NUREG-1437, Supplement 29
Vol. 1

Generic Environmental Impact Statement for License Renewal of Nuclear Plants

Regarding
Pilgrim Nuclear Power Station

Final Report – Main Report

Figure 2-7. Gulf of Maine Winter Flounder
Spawning stock biomass (SSB) estimates during 1982 to 2004 reported in GARM (2005) and the total biomass that produces the maximum sustainable yield for the fishery (B_{MSY})
(As provided in: NEFMC 2006b)

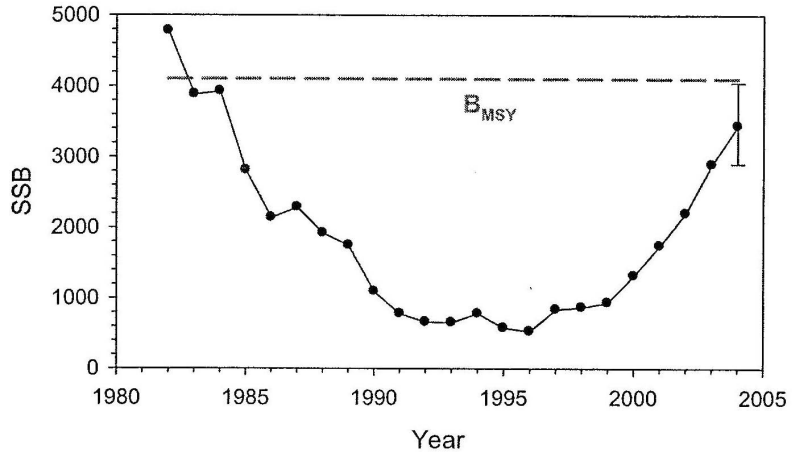
Comment: Page 2-68, Line 21 - The reference "NEFSC 2005" appears to be the source for "Figure 2-7"; however "NEFMC 2006" is listed as the source for "Figure 2-7". Therefore, there appears to be a discrepancy. (PNPS-D-MM)

Figure 2-8. Winter Flounder Abundance Estimates in Northwestern Cape Cod Bay
(As provided in: MRI 2006)

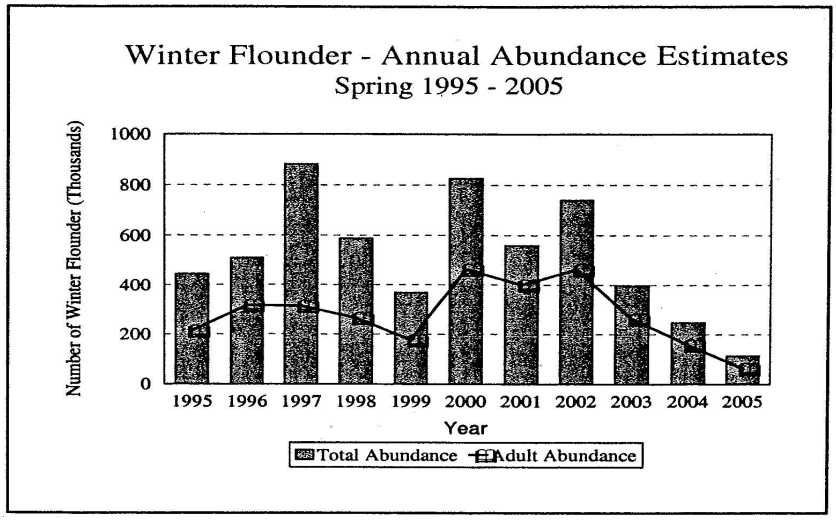
Page 2-68, lines 23-29: states "*... data from the local population ...indicate that the annual abundance estimates of winter flounder in western CCB continue to decline (Figure 2-8).*" This sentence implies that the "trends" from the prior paragraph are not matched by the abundance estimates in the vicinity of PNPS. This is an erroneous conclusion for two reasons: 1] it is an incorrect inference from the data in Figure 2-8 (PNPS's annual 'Area Swept' monitoring effort), and 2] it falsely presumes that the information given in the first paragraph constitutes evidence that a 'trend' is present in the Gulf of Maine winter flounder abundance data (see comment above). Simply because the 2005 winter flounder collection numbers were the smallest catch over the time series does not mean there is a declining trend (based on the three previous years). In fact, the number of sub-adult winter flounder collected in the most recent 'Area Swept' survey increased substantially. The 2006 estimate of immature winter flounder (total length less than 280 mm) was the fourth highest over the 12-year series, indicating that a healthy level of recruitment continues to occur in the vicinity of PNPS (see Figure 1 on the following page). Given that fish populations will often exhibit substantial variations as a natural consequence of environmental factors, the fluctuations observed over the 12-year history of the 'Area Swept' winter flounder abundance monitoring do not constitute a declining trend.

Figure 4-1. Equivalent Adult Summary of Entrained and Impinged Winter Flounder from PNPS (Source: Normandeau 2006a)

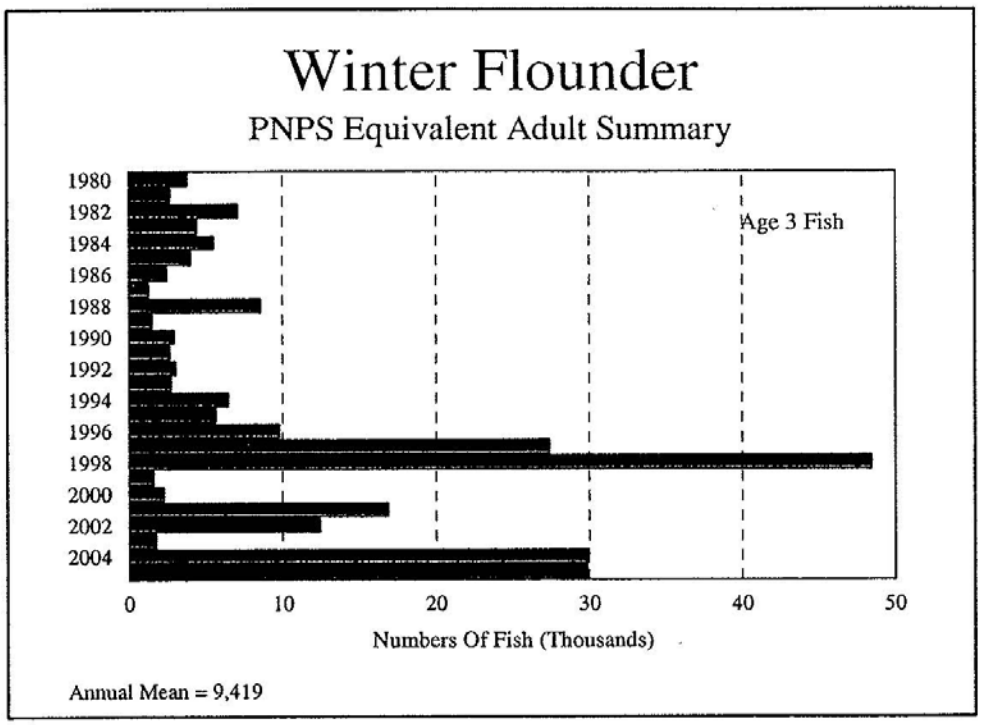
Comment: Page 4-22 - Figure 4-1 does not represent "the loss of adults from the local stock," it is the "numbers of equivalent adult winter flounder estimated from entrainment and impingement data at PNPS." It should be made clear that the equivalent adult method yields a hypothetical estimate not an actual measurement. (PNPS-D-MM)

Response: *The comment is noted and the edits suggested by the commenter have been incorporated into the text that describes Figure 4-1.*

Figure 2: Mean numbers of wild young of year winter flounder collected by 100-ft beach seine in Plymouth Harbor (during the month of July) from 2002-2006.

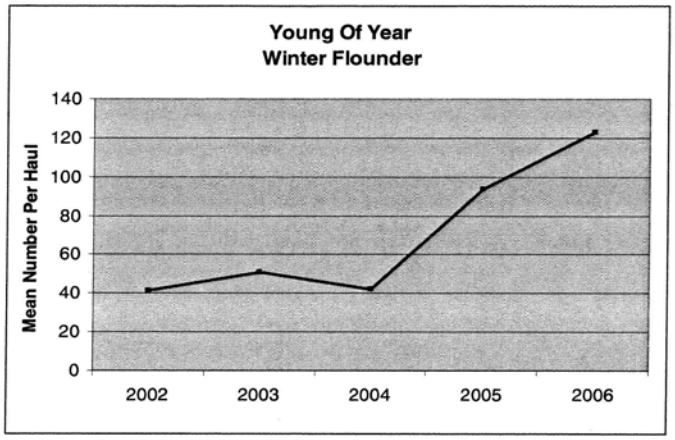
Additional information currently available also suggests that the winter flounder population in the Cape Cod Bay area is not in a downward trend. Beach seine sampling in Plymouth Harbor completed in conjunction with Entergy's young winter flounder hatchery release program indicate that numbers of young, wild fish remain strong and in fact have increased over the past two years (see Figure 2 below). It is also interesting to note that numbers of young fish collected during the summer do not appear to be correlated with the number of larvae entrained at PNPS the previous spring. This local field data suggest that numbers of winter flounder entrained do not translate into reduced numbers of young fish.
